ADDENDUM No. Six (6)

IFB No. 2021-239

CONSTRUCTION, COLLIN COUNTY ADULT DETENTION FACILITY, PHASE 1 ADDITION

ADDENDUM NO. 4

**VIDEO MANAGEMENT
AND RECORDING
SYSTEM DIAGRAM**

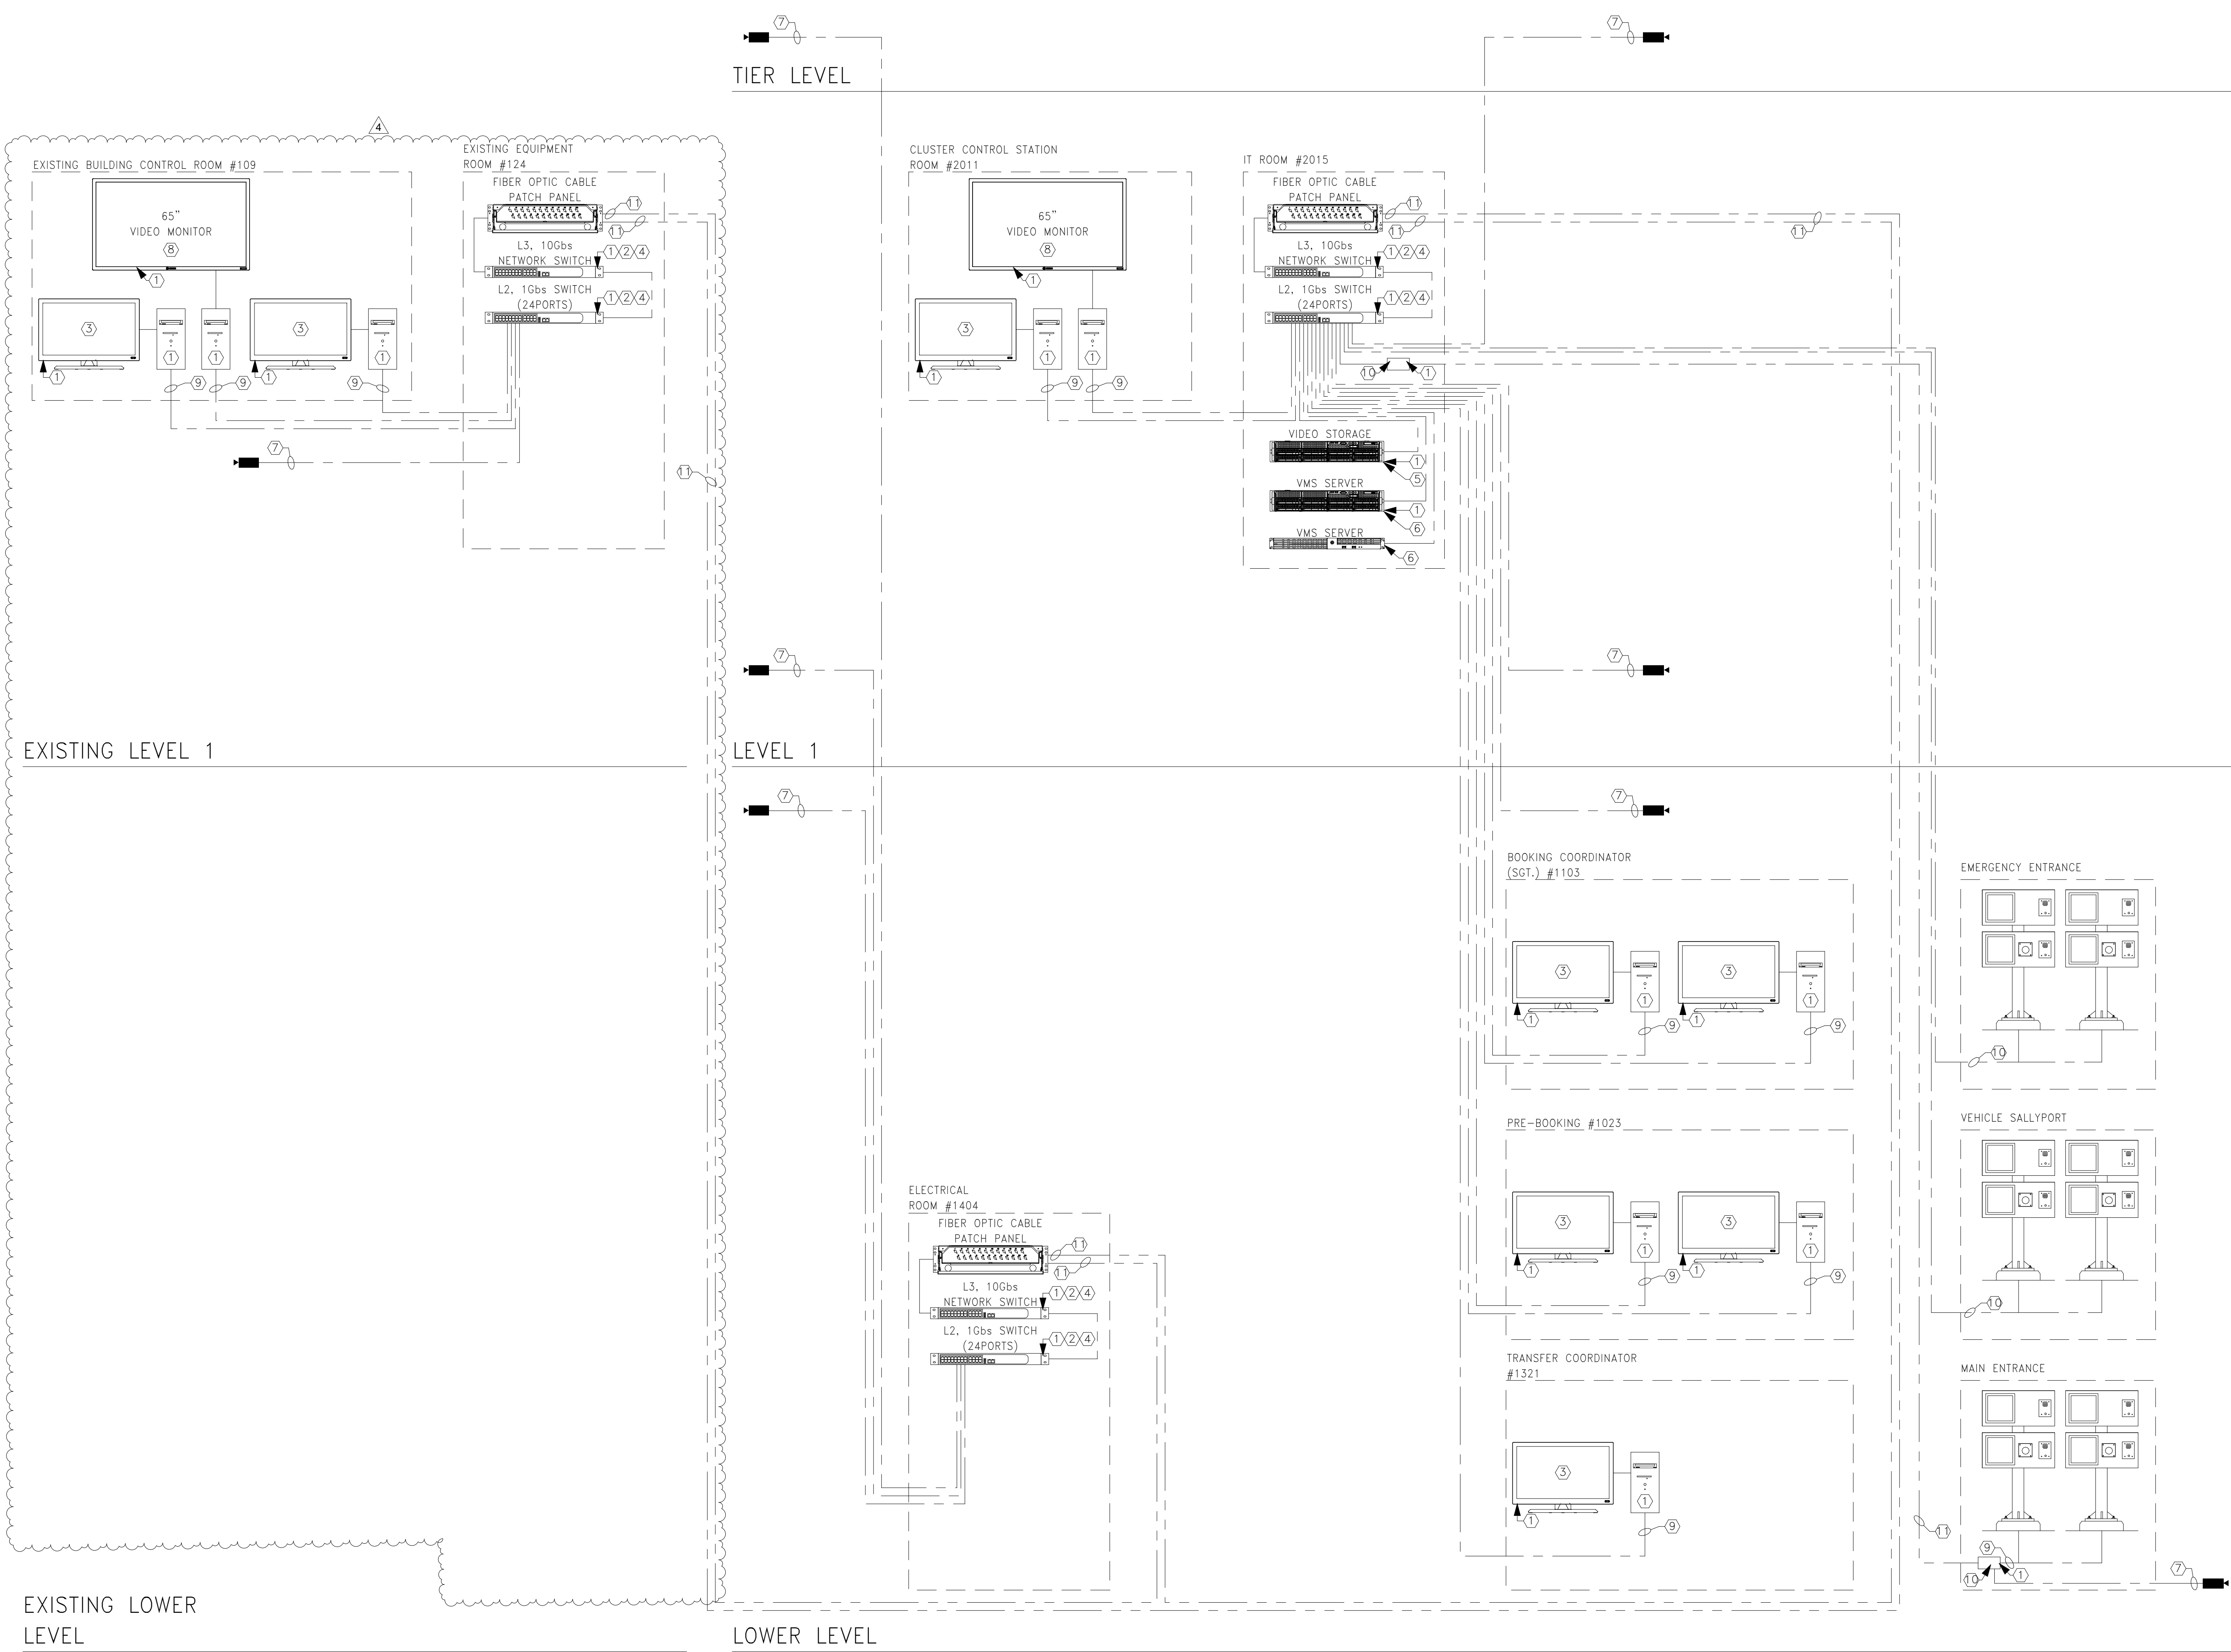
- A. Modified Diagram to correct Existing Equipment Room #129 to #124.
- B. Corrected Diagram by moving Existing Equipment Room #124 to level 1.
- C. Corrected Diagram by moving Existing Building Control Room to level 1.

3 VAULT DETAIL
N.T.S.

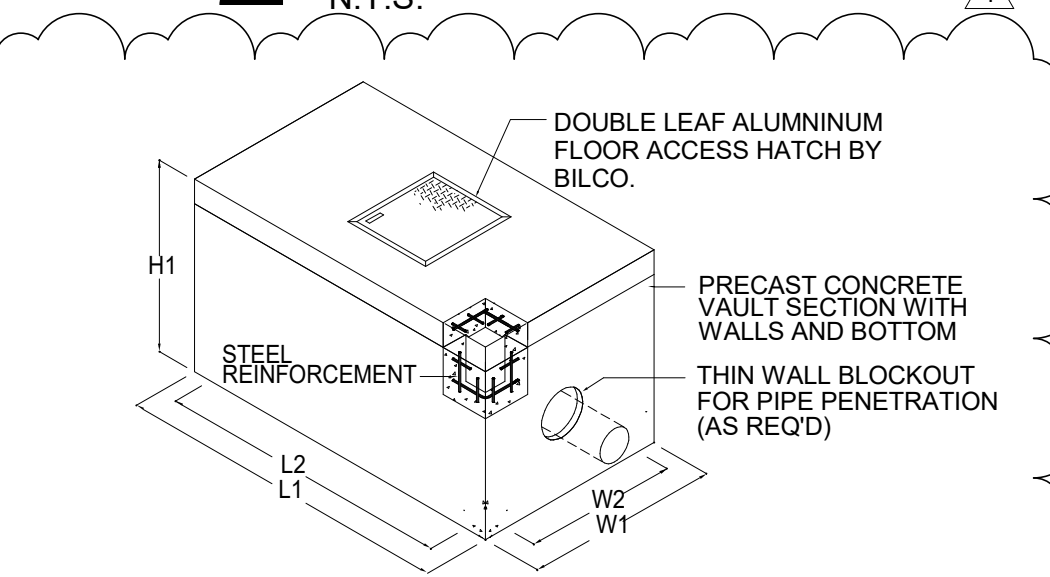
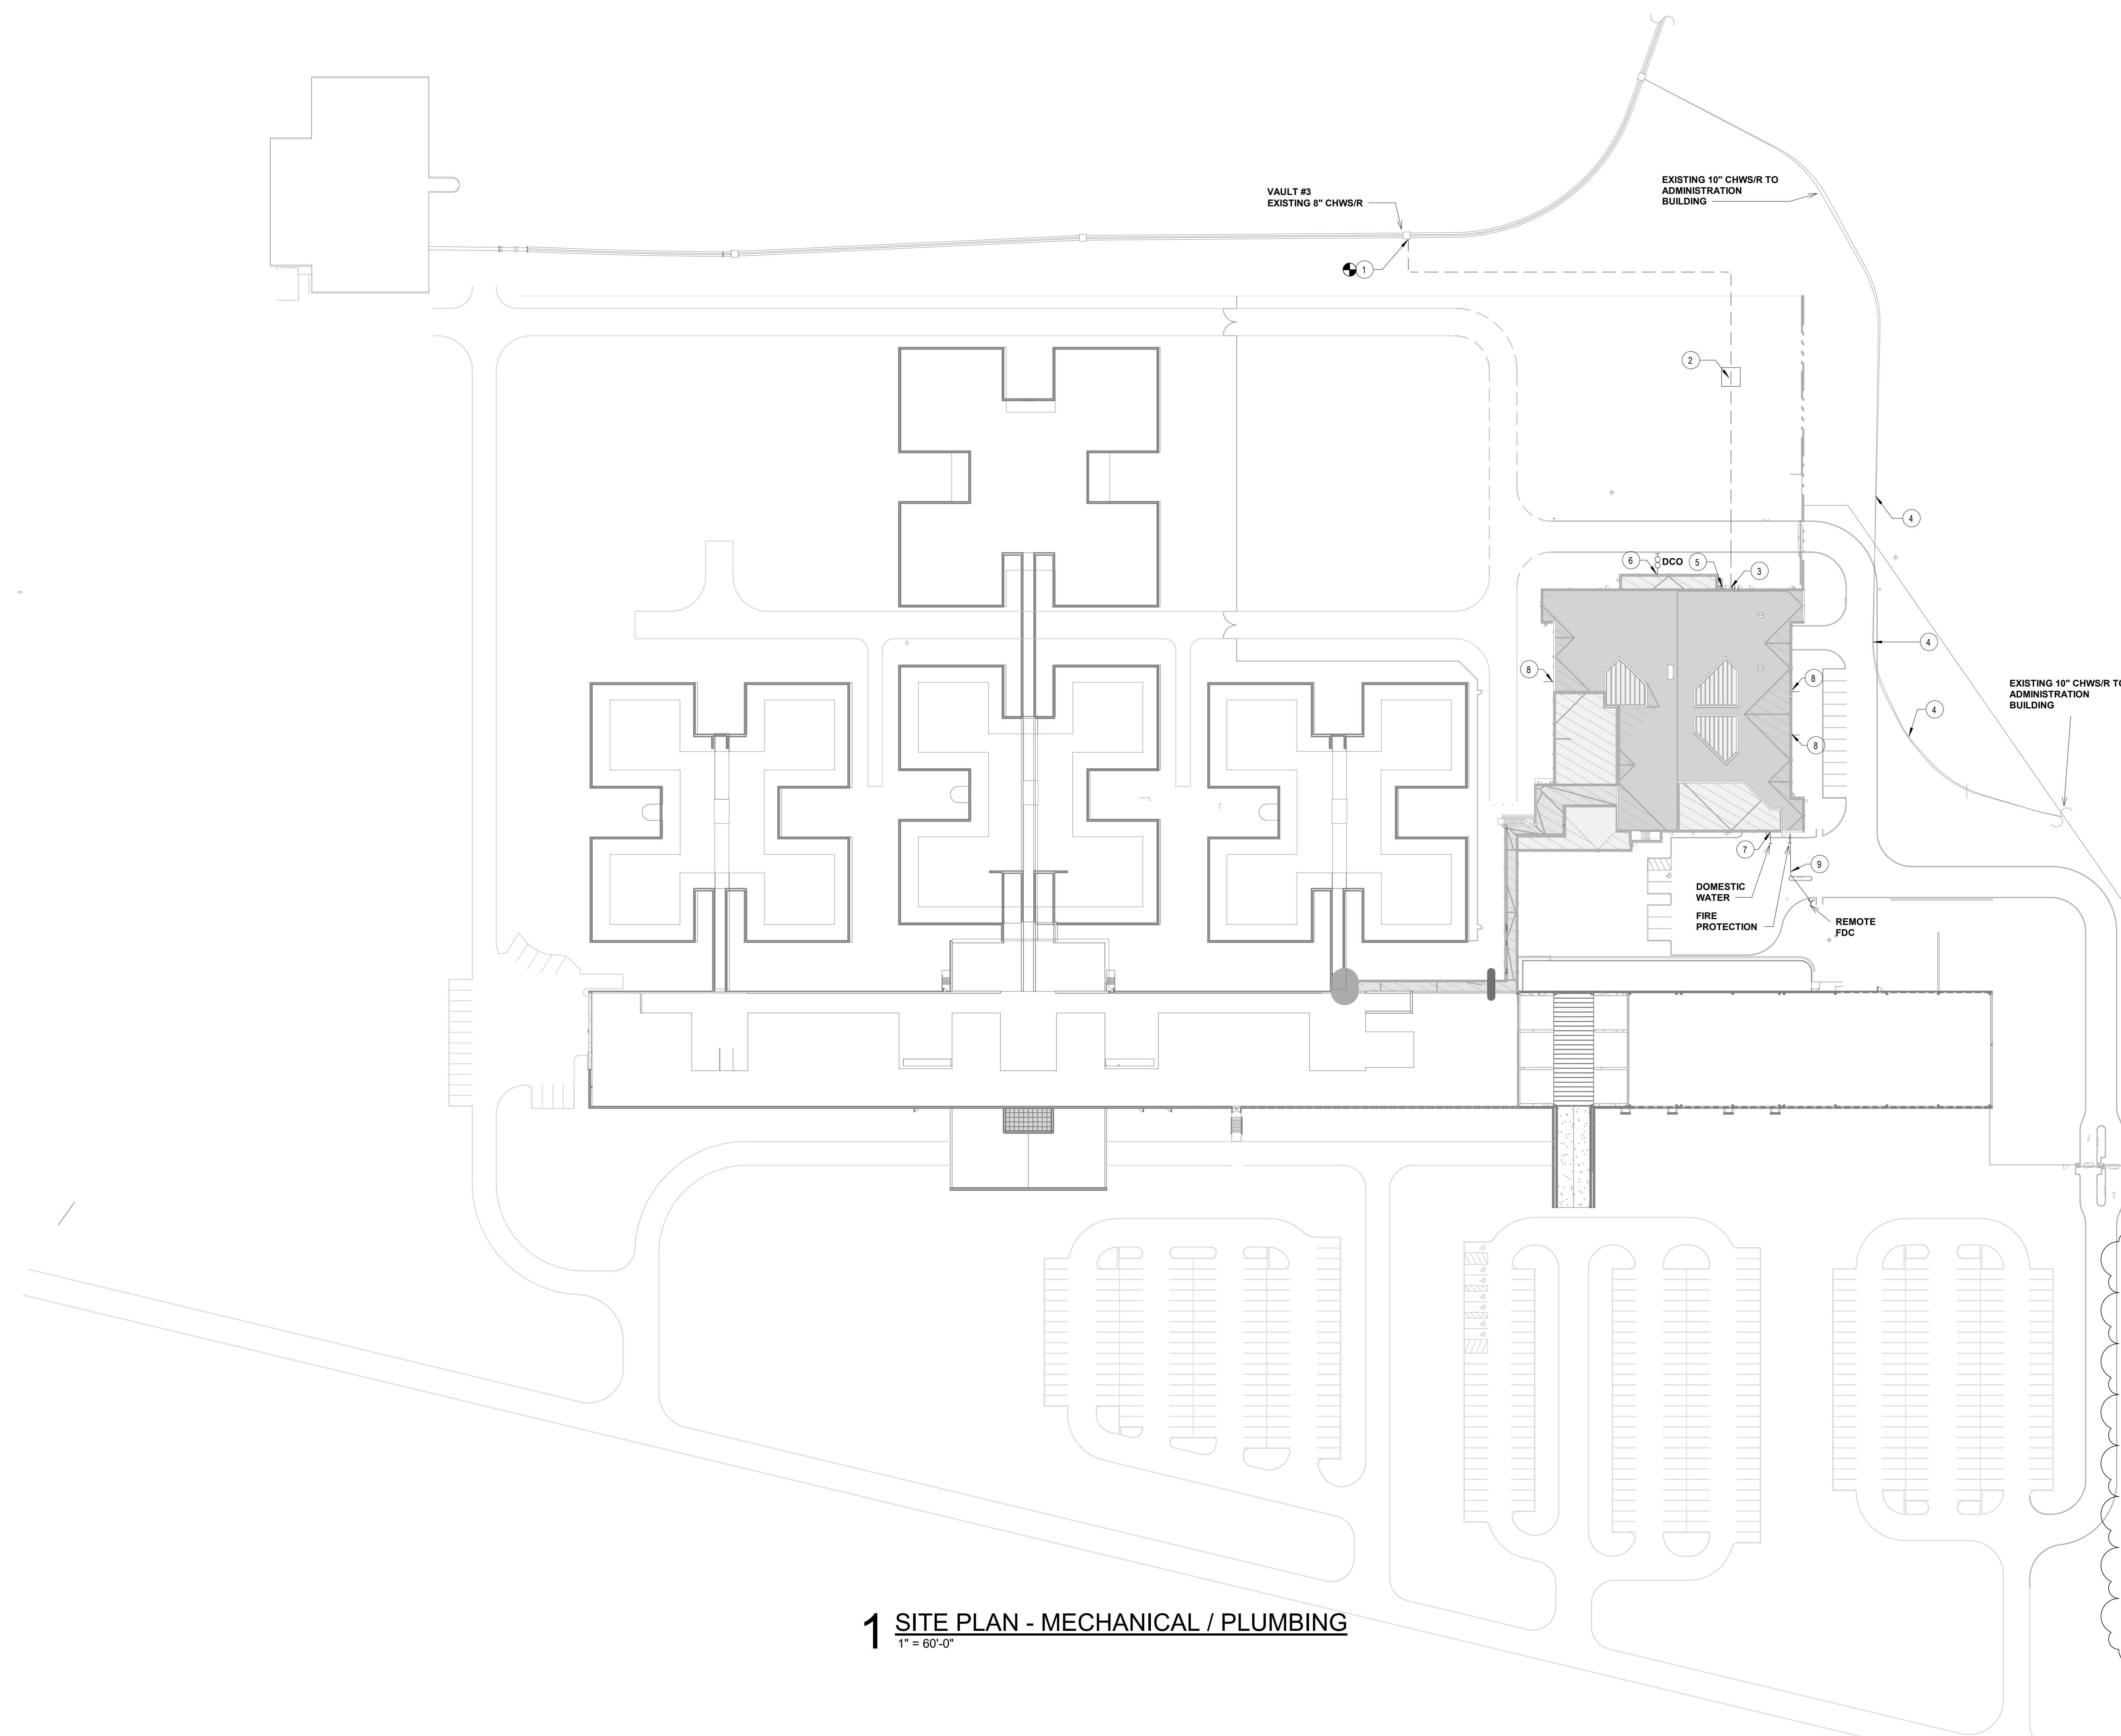
- Item No. 6. Sheet – CVR**
A. Updated to include addendums.
- Item No. 7. Sheet – M100**
A. Added detail 3 and note 2.
- Item No. 8. Sheet – ES227**
A. Modified floor plan view to include location of existing Equipment Room #124 and existing Building Control Room #109.
- Item No. 9. Sheet – ES501**
